OFFICE MEMO

FILE REF: Proposed Plan Change
TO: Alyson Schuler
FROM: Rebecca Ramsay (Landscape Architect)
DATE: 27.06.2005
SUBJECT: The Kirimoko Block - Wanaka

**APPENDIX 5: DETAILED PLAN INDICATING POTENTIAL
DEVELOPMENT OF THE KIRIMOKO BLOCK.**

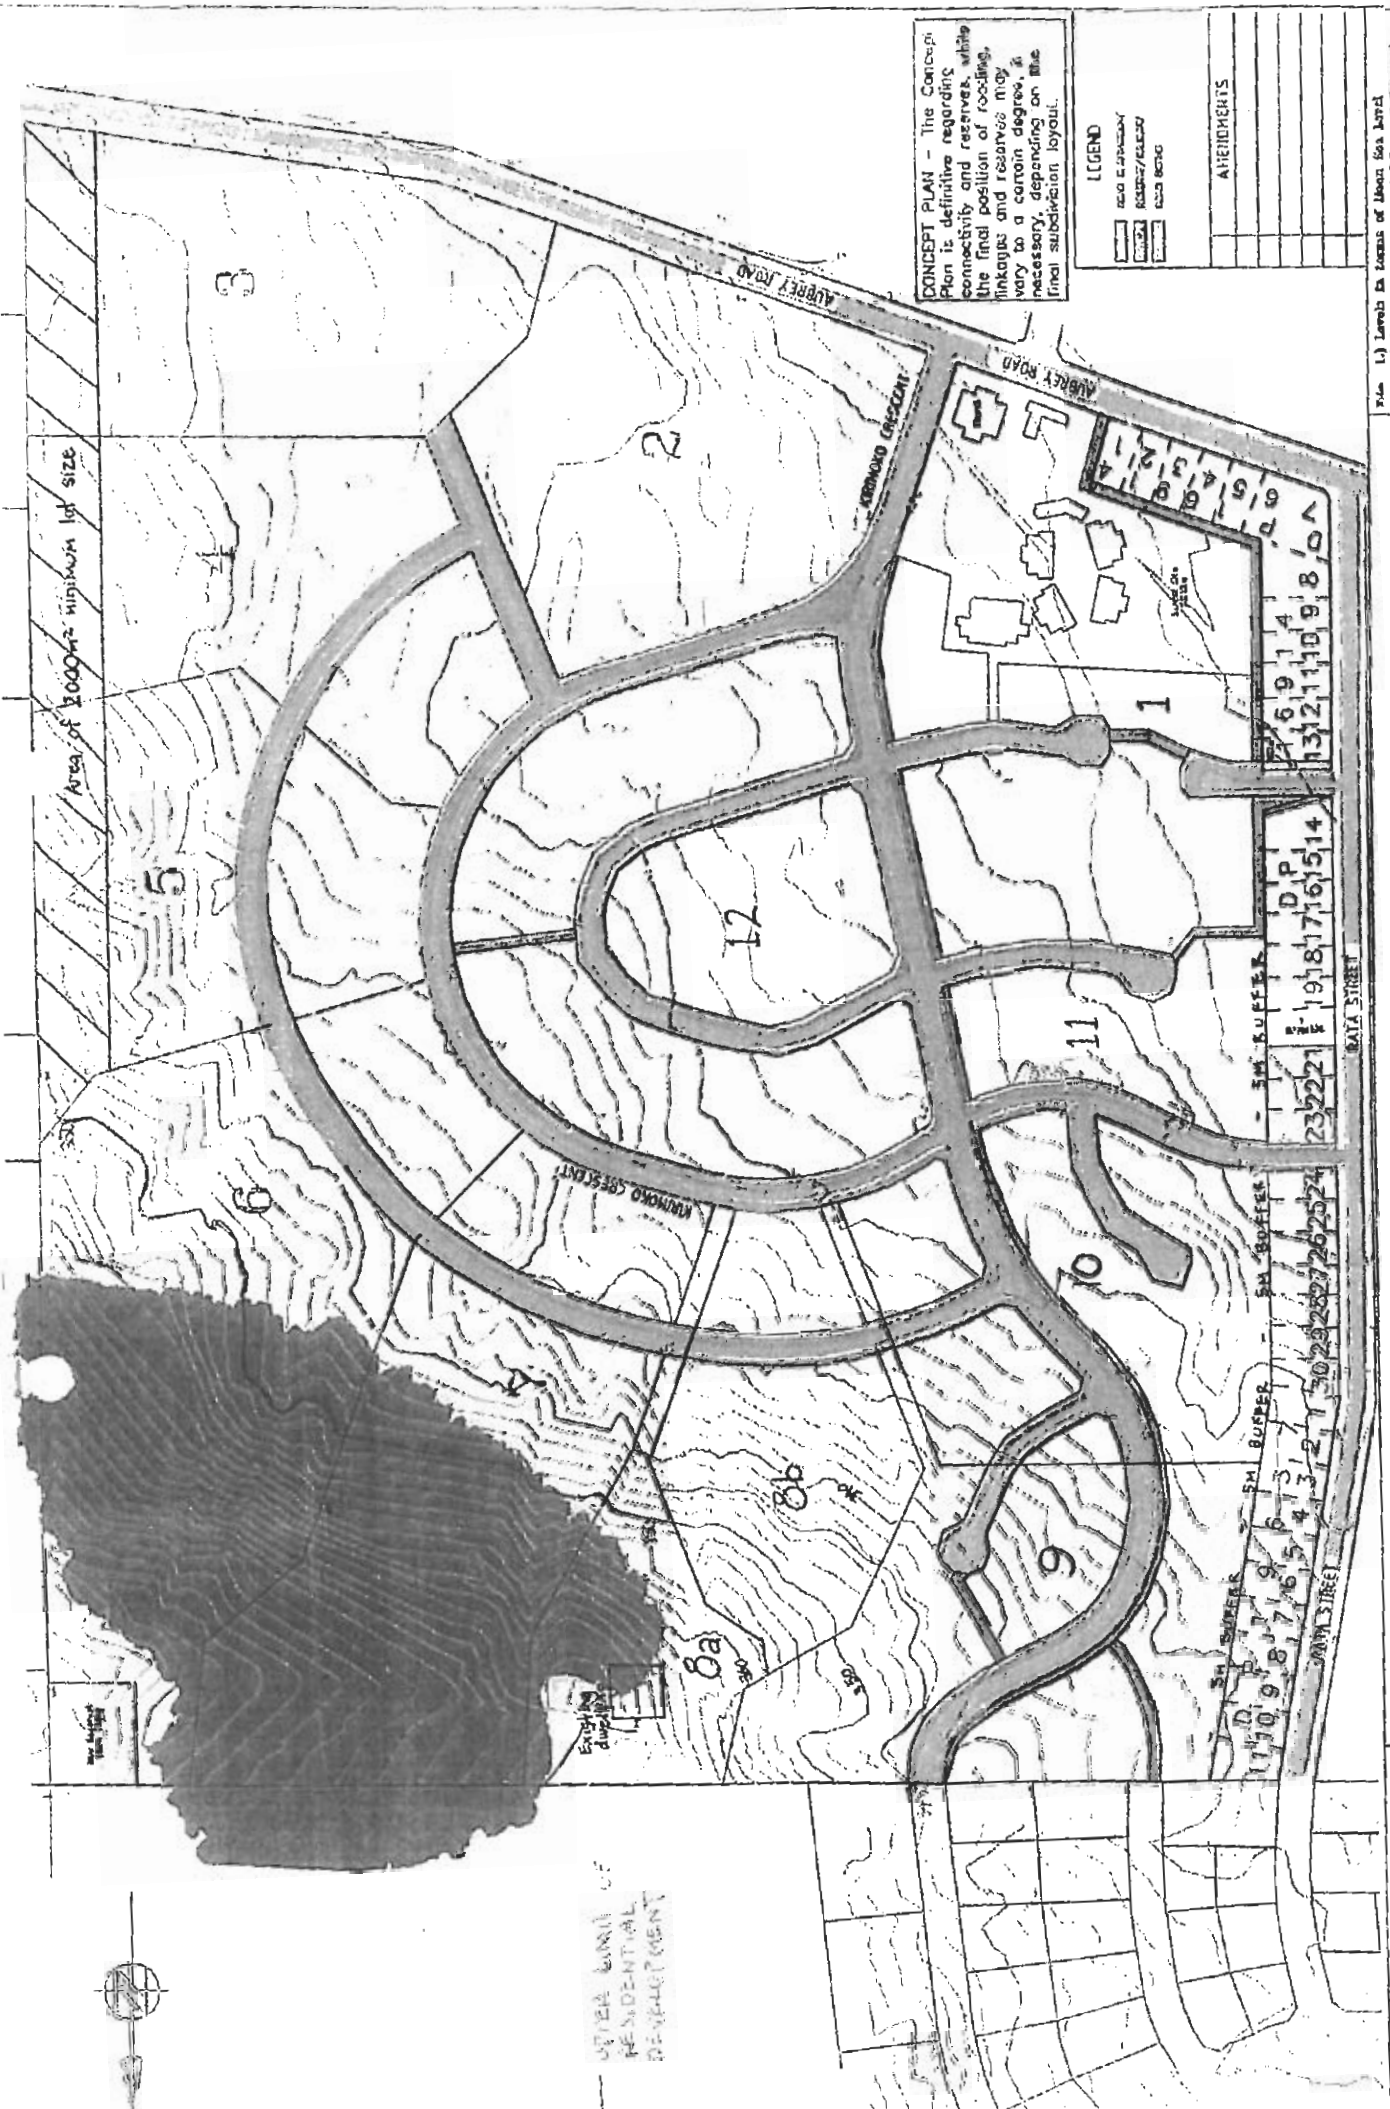
75. Appendix 5 is a more refined version of my concept plan that indicates how I believe a future zone change could occur that would enable suitable retention of the visual amenity values of the site within the wider context of both urban and rural landscape character.

79. I consider development as indicated on my plan attached as Appendix 5 will be in keeping with the recent Environment Court decision, will maintain the amenity value of the more prominent parts of the site and will provide a strong urban edge to Wanaka. The following requires additional consideration in terms of appropriate planning tools to resolve issues raised by the landowners and discussed within my report:
